Delegated Report

Planning Application No: 20250740

Location: 110 Singlewell Road, Gravesend DA11 7PT

Description: Formation of vehicular access on to a 'C' classified road and provision of one off-street parking space in front garden with associated hard standing.

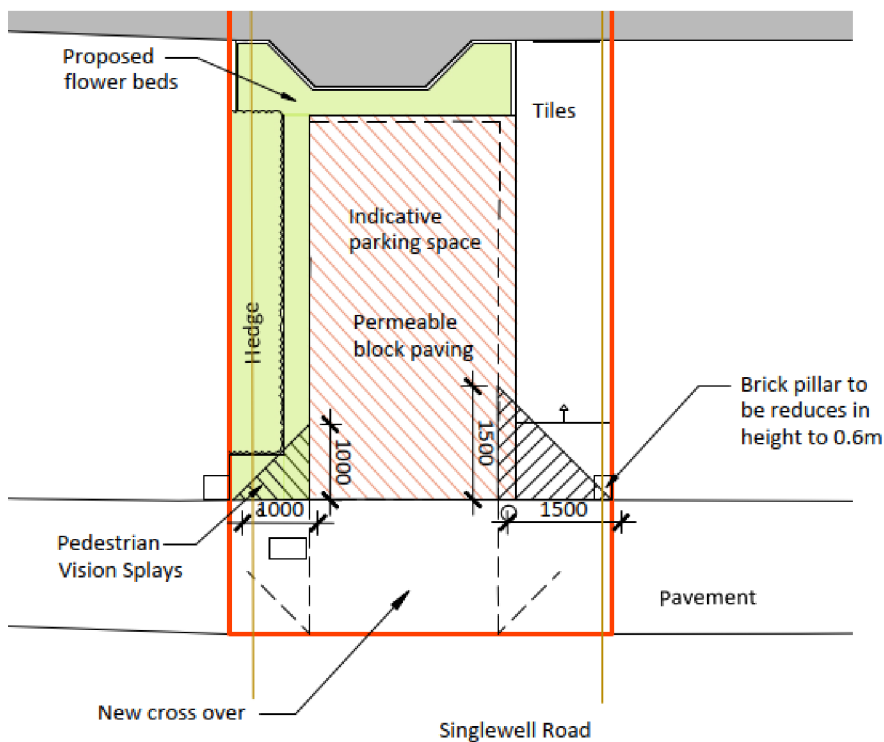
The vehicle crossing team have viewed the proposal, we would like to advise that the applicant would they need to meet our minimum measurements criteria of 4.8m depth + 2.4m minimum width for perpendicular parking.

Kent County Council's (KCC) minimum dropped kerb would be 4 dropped kerbs and 2 tapers (5.4m width). Where a larger construction or extension to an existing dropped kerb is requested, approval will only be granted if there is no significant impact to on street parking demand.

There is a KCC drainage asset that has been identified at the point of the crossing this will need approval from the local drainage engineer that that this would not be affected by the installation of a dropped kerb.

The applicant will need to demonstrate that visibility splays can be achieved.

There is a concern over highway safety should a vehicle exit property in reverse. Approval would be subject to an inspection by a KCC officer and is not guaranteed.
